Rezoning Transportation Analysis

Petition Number: 2019-151

Date	Description
11-21-19	First Review

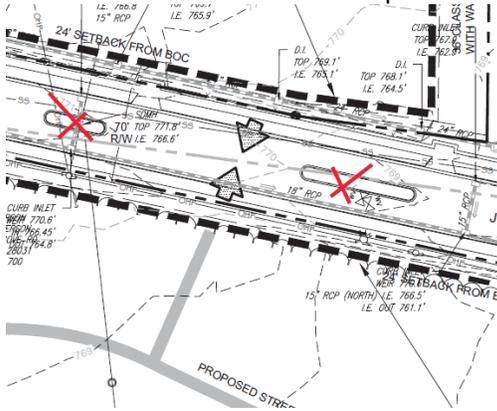
3. The petitioner should revise the site plan and conditional note(s) to remove the access off of the Northern portion of Johnston Oehler Road.

4. The petitioner should revise the site plan and conditional note(s) to extend the median on the southern side of Johnston Oehler Road to create the restriction needed for a RI/RO.

- The petitioner should revise the site plan and conditional note(s) to remove medians on the East/West portion of Johnston Oehler and restripe for two-way left turn lane to allow more storage for left turns into both accesses of the development.
